Resource Consent Application LU/0077/23 – Further Information Response

Re: Functional Need to Quarry Sand at 71 Newcombe Rd, Cambridge

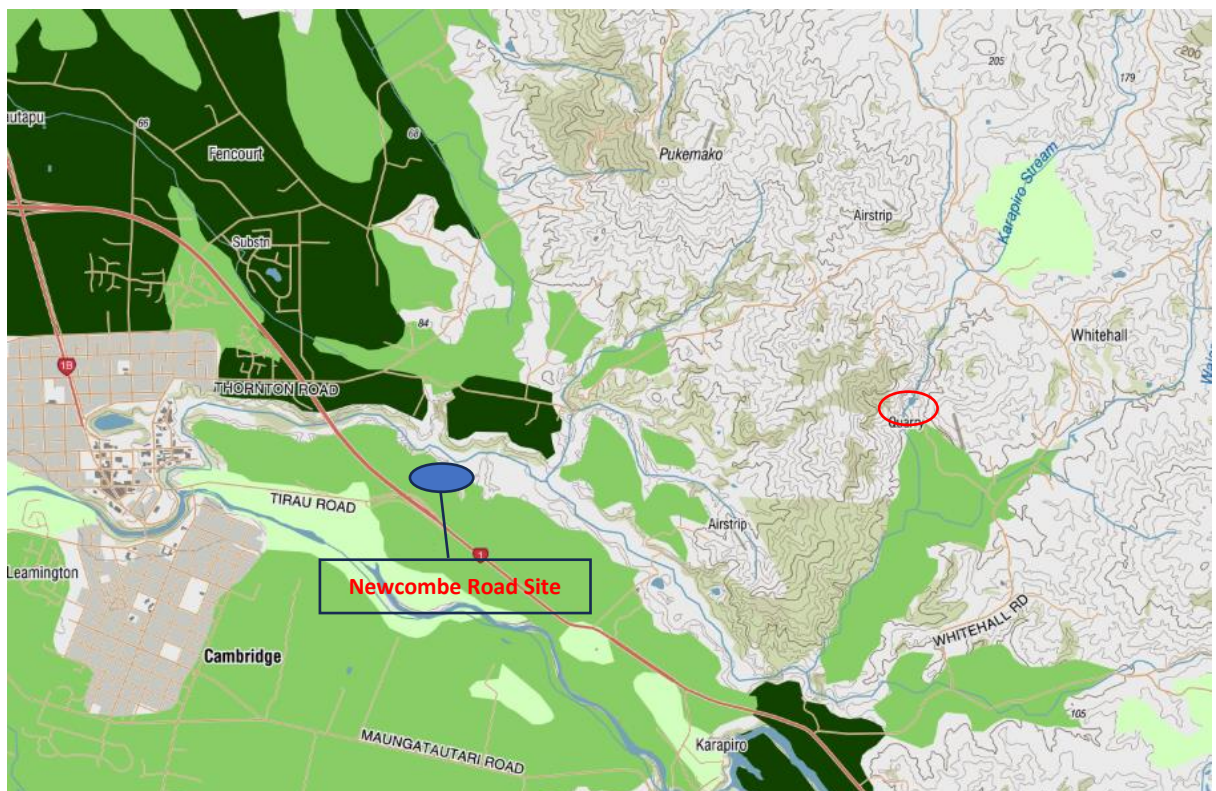
- (15) *The wording of sub-clause 3.9(2)(j)(iv) is potentially problematic in terms of how this should be implemented. Taken literally, it would essentially mean that any quarry activity would only satisfy the exemption criteria if the same material could not otherwise be supplied from around New Zealand. This would appear to be a fanciful proposition which fails to take into account any economic, logistical and market factors involved with the supply and transportation of sand or other aggregate. In our opinion, the interpretation of this sub-clause will need to take into account the practical issues of supply. However, that said, we note your AEE refers to other local quarries and that these are also located on high class land. Can you please provide further assessment and commentary on how the same resource could be supplied from around New Zealand in accordance with sub-clause 3.9(2)(j) iv and any commentary on how this sub-clause should be implemented?*

In terms of how an assessment of this clause should be implemented, an assessment could be made as to why HPL land around New Zealand should be used for this specific aggregate extraction, rather than non HPL. This has been outlined with the AEE in relation to river terraces within the Waikato Region having the best possibility for high quality concrete sand, like that resource that has been found on Newcombe Road. Within the Waikato poorer quality soils, or lower-class land is usually found within rolling or steep country away from current or historic river channels/terraces.

I have provided an image below from the Manaaki Whenua Our Environment website identifying the location of HPL (green shading) in and around our site and land considered to be non HPL (no shading). I note the location of the RS Sand site, as well as the location of a hard rock quarry within the local area. I have identified these sites to further reinforce that aggregate, be it hard rock or high-quality concrete sand is an in situ resource and not subject to movement depending on local or central government policy. One type of aggregate is found predominantly on high quality soils, another on lower quality soils, but both play an important role in New Zealand's regional infrastructure and building industries. On that basis WDC can assess this proposal as having a significant regional public benefit that could not be achieved using resources from non HPL land or from regions outside of the Waikato/Bay of Plenty or Auckland regions.

Project	RS SANDS
	Title	Erosion & Sediment Control Plan Processing Area and Site Establishment
Drawn ZW	Checked CS	Drawing No. ESCP-PA-01
		Sheet No. 1

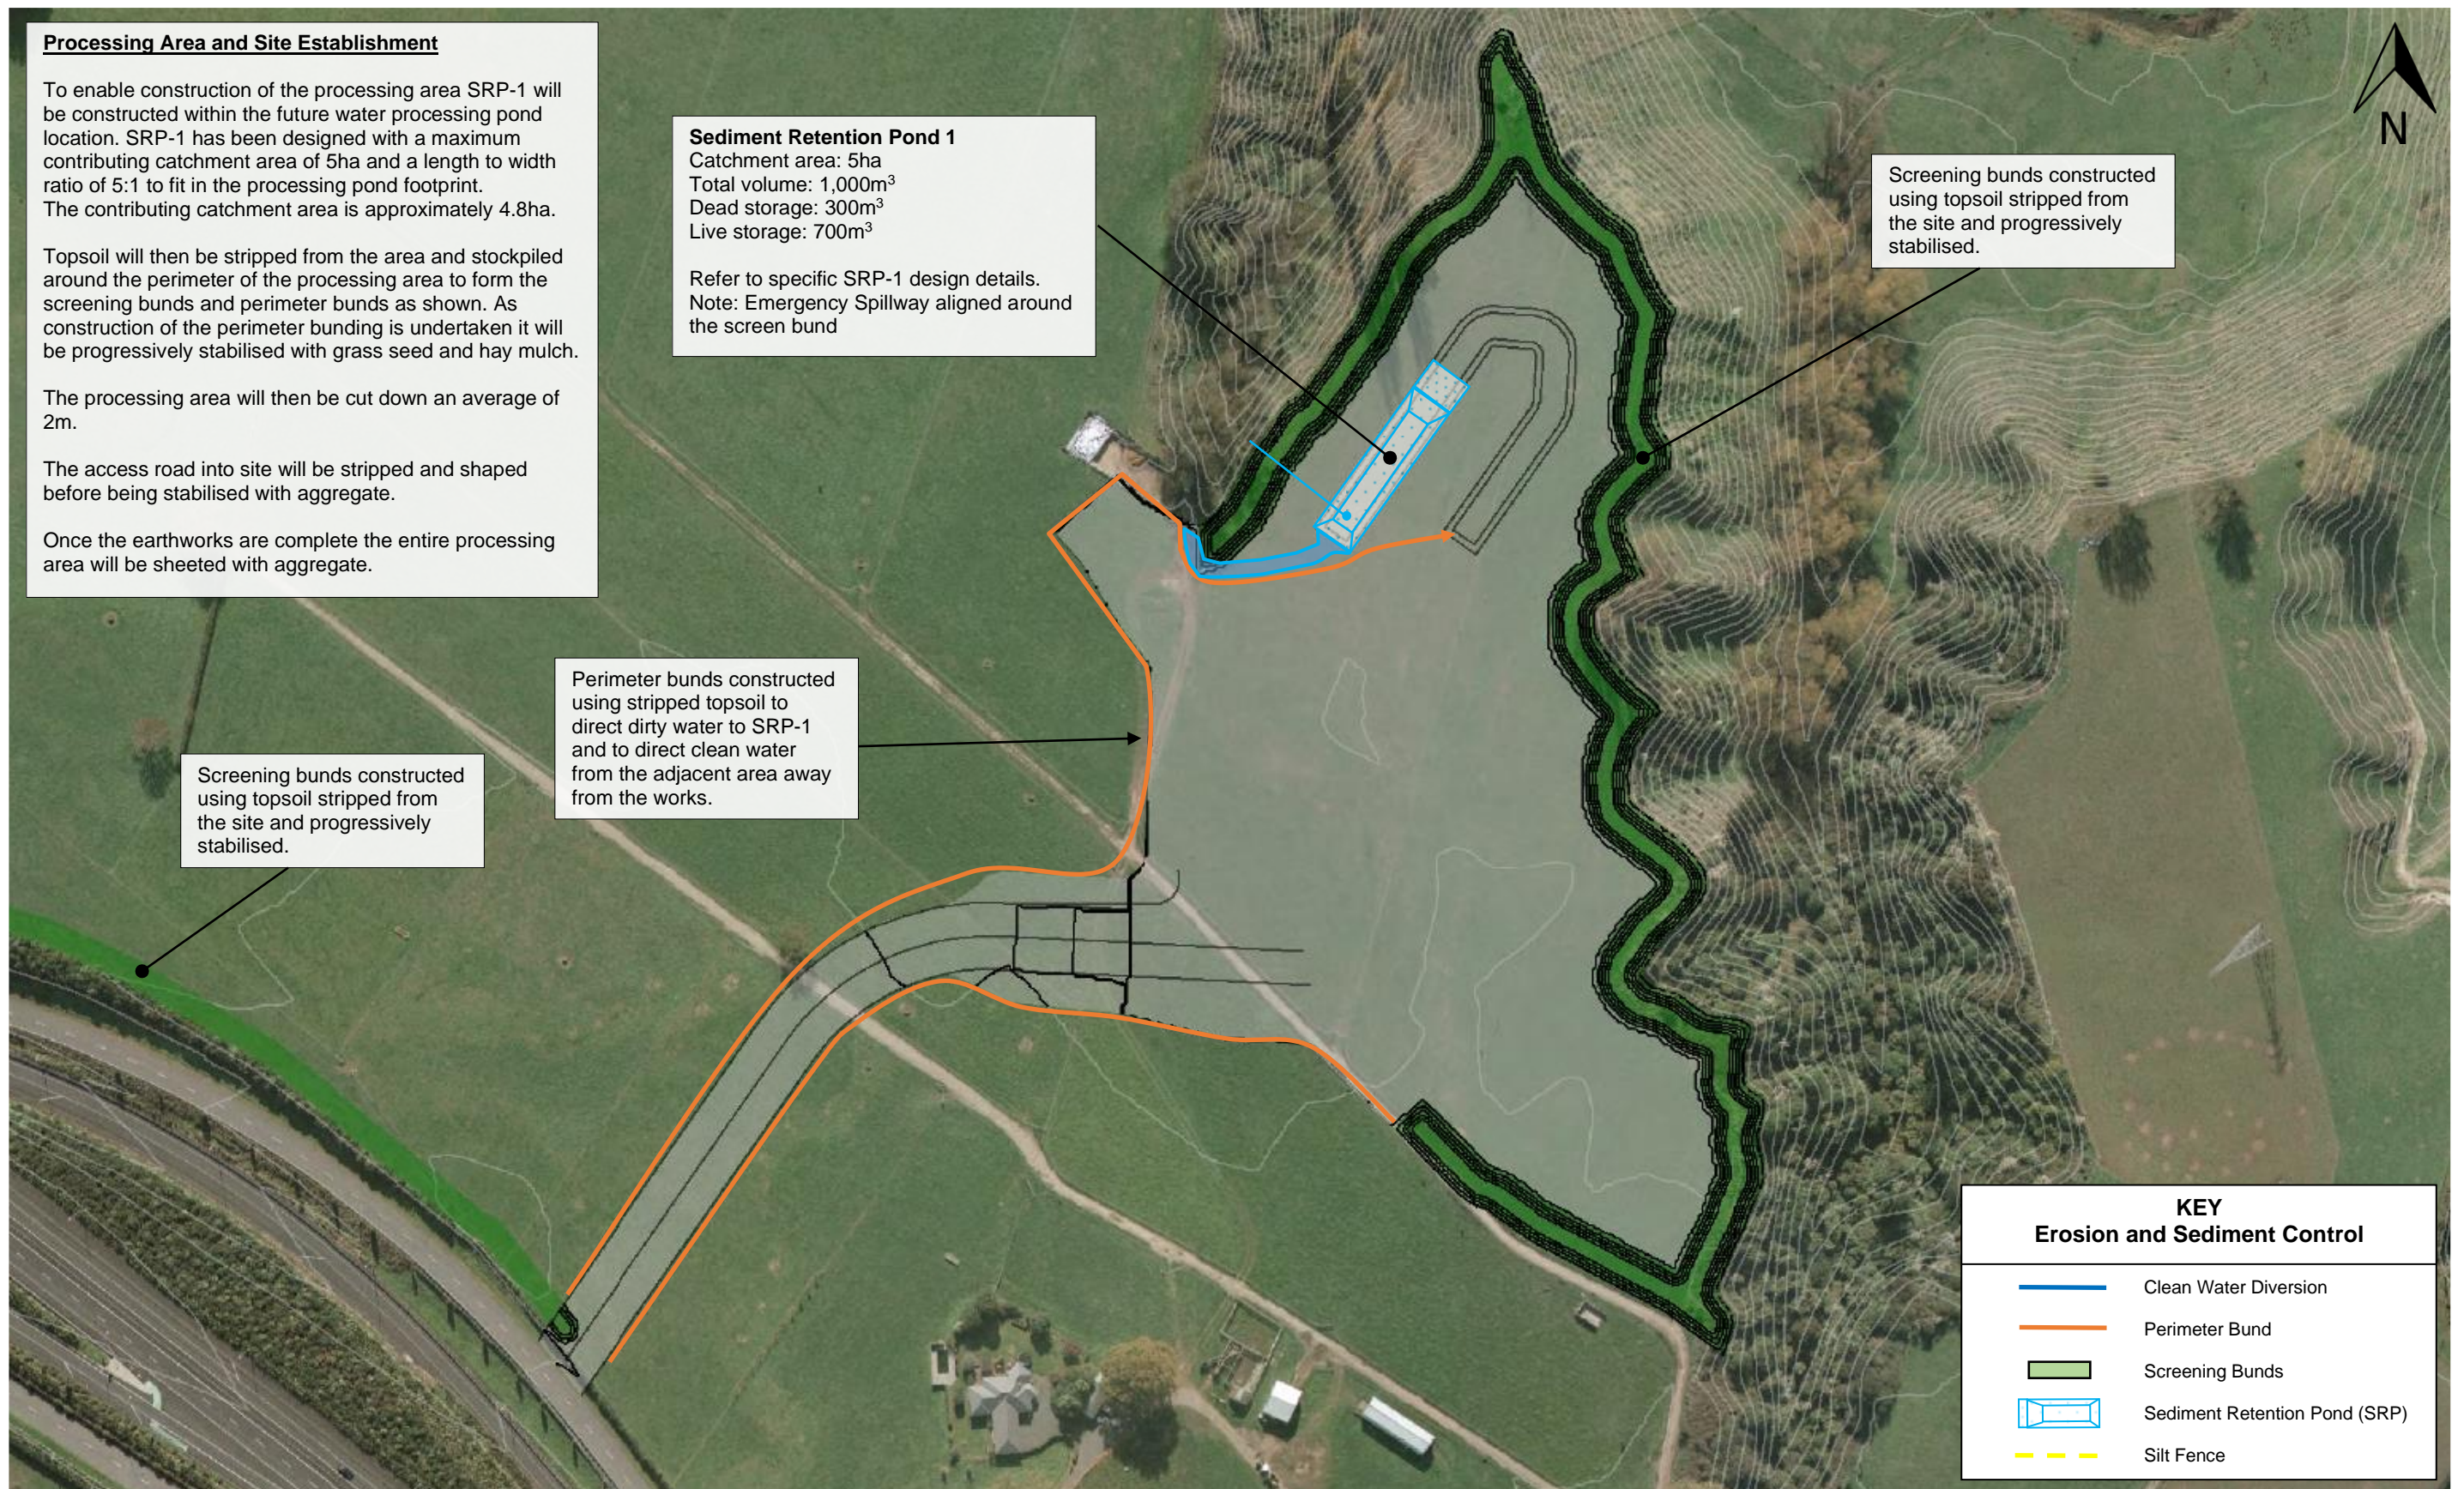
- (5) *Erosion and Sediment Control Plan provided by Southern Skies Environmental Ltd did not include the erosion and sediment control drawings in Appendix A. There is a table with the drawing numbers and titles, but the actual drawings were not provided. Please provide.*

These were provided as Appendices O2 and E in the original application. Please confirm receipt of these? We note there was a revision to ESCP-PA-01 completed following a request for further information from WRC, this plan has been attached as **Attachment A** and is Revision B. This revision has been accepted as having resolved the WRC request for further information.

REV	DATE	REVISION DETAILS	APPROVED
A	21.01.22	Draft for review.	
B	05.07.23	Clarification of spillway alignment (response to s.92)
